IO-Link

Corrigendum & Package 2020

IO-Link Interface and System Specification V1.1.3

**Version 1.0
January 2021**

Figure 101 – State machine of the Configuration Manager

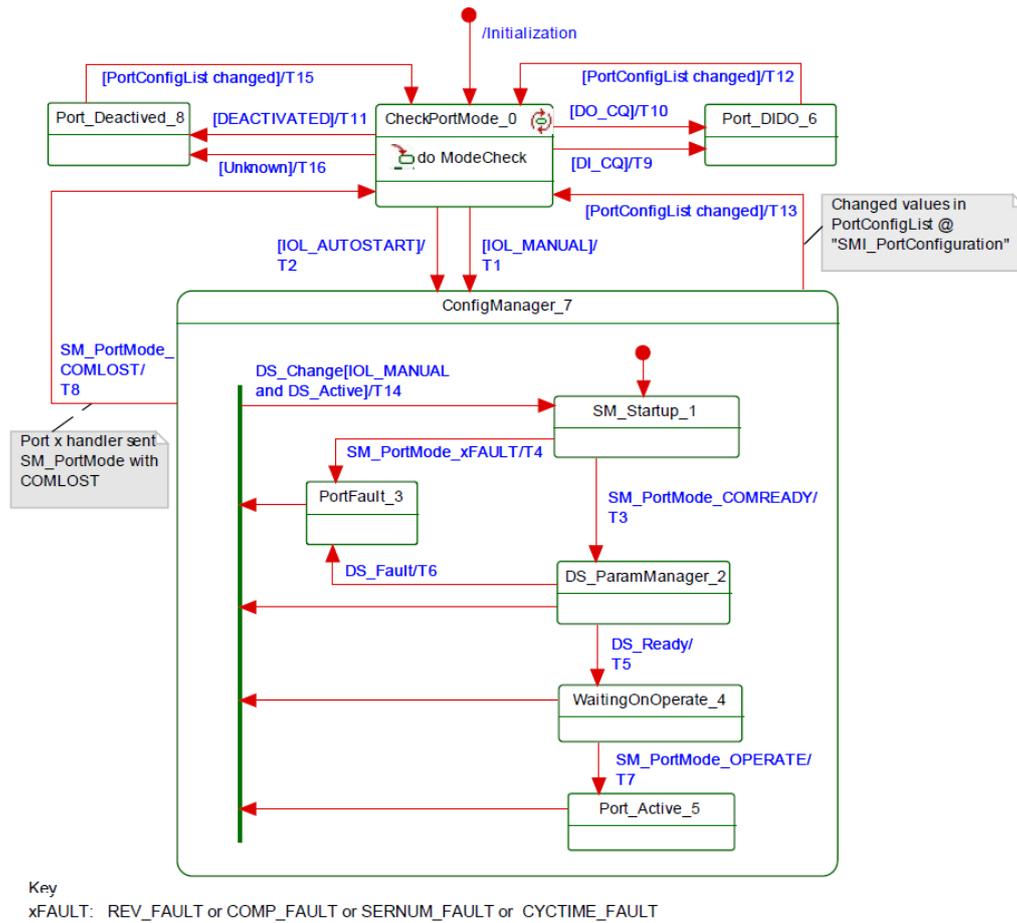
Problem	The Triggers of Events "0xFF21" and "0xFF26" do not match the indicated transitions T9 and T12 respectively in state machine of Figure 101. Thus, shall an Event "0xFF26" be thrown at any state change?
Solution	Introduction of the Standardized Master Interface (SMI) in V1.1.3 and the new Configuration Manager state machine in Figure 101 make the Event triggers a relict from previous designs in V1.1.2 that are partly not recommended for implementation as already stated in V1.1.3. Remodeling of the entire Port Event scenario led to the following changes: 1. Triggers of Events "0xFF21" to "0xFF27" and "0xFF31" are removed (see Annex D.3 in 4.4). 2. Events "0xFF26" and "0xFF27" are optional. New triggers are defined in Annex D.3 in 4.4. 3. General rule: Each change of PortStatusInfo (see Table E.4) causes an Event via SMI_PortEvent (Notification, EventCode = "0xFF26"). For details see new Annex D.3 in 4.4.

Problem	Since Event "0xFF21" should not be supported anymore it is not clear how the readiness of a Device shall be reported. A disappearing "0x1800" Event is not an option since a disappearing Event without an appearing Event makes no sense. Throwing an appearing "0x1800" Event at any time after configuration until the Device is in OPERATE is not acceptable due to possible problems with upper-level systems.
Solution	<ol style="list-style-type: none"> 1. The state machine of Configuration Manager in Figure 101 shows transitions leading to new information in SMI_PortStatus.PortStatusInfo (see Table E.4). Suggested changes to these transitions in Table 126 are documented below. 2. The new information in Table 126 leads to Port Events specified in Annex D.3. Changes are documented in Annex D.3 below 4. This Annex D.3 now defines mandatory and optional Port Events 5. It also makes stringent use of the Event appearing/disappearing rule 6. It also details what is meant with "Port status changed" and its indication 7. The Port Events distinguish between errors caused by the communication system and those caused by the application (Event "INSTANCE"). Consequently, Table A.17 is changed: Value = 4, Definition = Application (APP); Value = 5, Definition = System (SYS).

76 New clause 11.3.2 – "State machine of the Configuration Manager" with colored corrections:

Figure 101 shows the state machine of the Configuration Manager. In general, states and transitions correspond to those of the message handler: STARTUP, PREOPERATE (fault or Data Storage), and at the end OPERATE. Dedicated "SM_PortMode" services are driving the transitions (see 9.2.2.4). A special state is related to SIO mode DI or DO.

Figure 101 together with Table 126 also shows transitions leading to corresponding changes in "PortStatusInfo" of ArgBlock "PortStatusList" (see Table E.4). Based on these transitions, Events are triggered via SMI_PortEvent. For details see Annex D.3.

170 New Figure 74 – "Activity for state "CheckCompV10"" with colored corrections

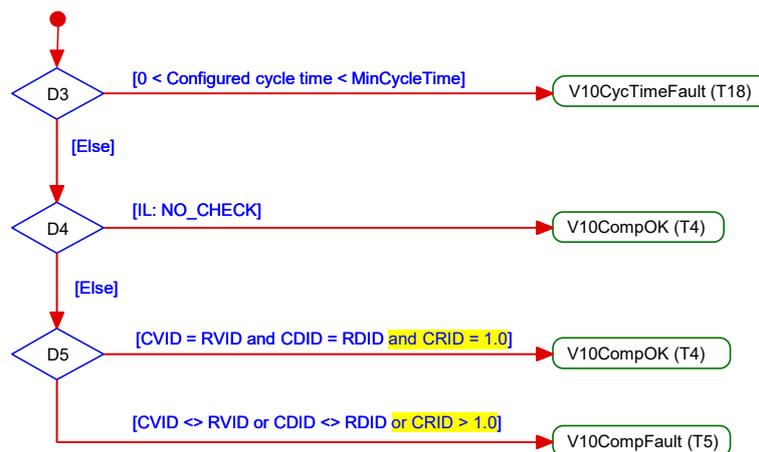
Problem	Objective of the Master compatibility check is to detect mismatches between the connected real Device and the Port configuration. This check also comprises the revision. However, the activity chart "CheckCompV10" in Figure 74 does not include check of the configured revision ID (CRID).
Solution	Change first decision in D5 to [CVID=RVID and CDID=RDID and CRID=1.0] and change second decision in D5 to [CVID<>RVID or CDID<> RDID or CRID>1.0]
Clauses	Clause 9
Subclauses	9.2.3.3 (Figure 74)
Impact on	–
Remark	See new Figure 74 below

Table 20 – Status of Port_Power_Off

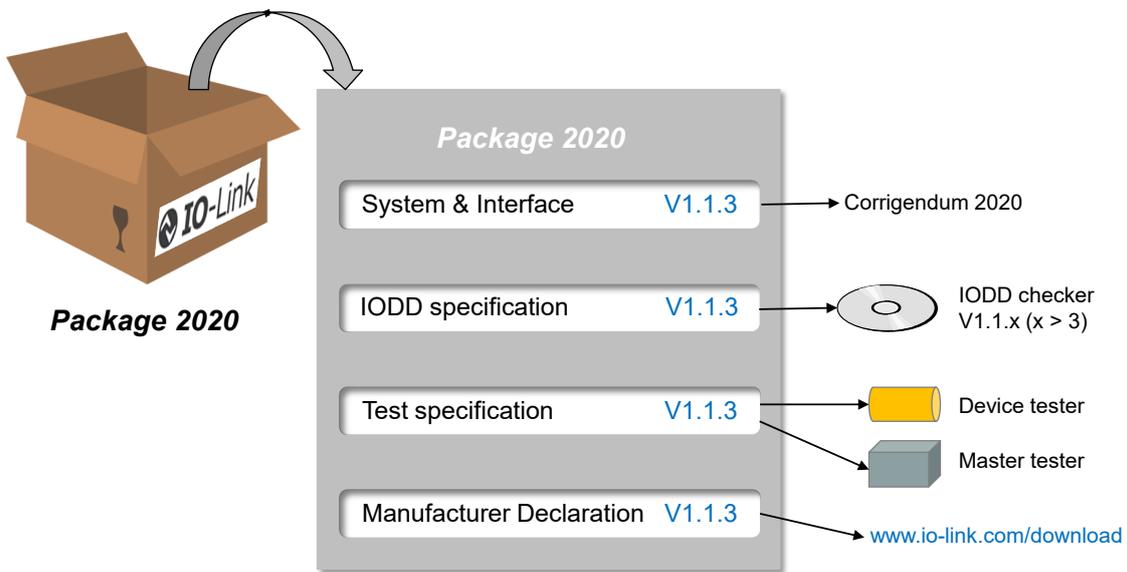
Problem	Service SMI_PortStatusList (E.4) provides in PortStatusInfo a state called PORT_POWER_OFF that is only activated if communication stops due a SMI_PowerPowerOffOn service. The explanation for this state is misleading when using Figure 101 (Configuration Manager) and the associated transition Table 126.
Solution	<ol style="list-style-type: none"> 1. At first, transition T3 in Table 126 is changed: "PortStatusInfo = NOT_AVAILABLE" instead of "PortStatusInfo = PREOPERATE" 2. Then, PortStatusInfo in Annex E.4 is changed: "3: Reserved" instead of "3: PREOPERATE" 3. Then, PortStatusInfo in Annex E.4 is changed: Definition of 254: PORT_POWER_OFF is now: "Shutdown of Port is active caused by SMI_PortPowerOffON"
Clauses	Annex E
Subclauses	Annex E.4 (Table E.4, PortStatusinfo)
Impact on	–
Remark	See SP-CR-ID 216 (Table 126)
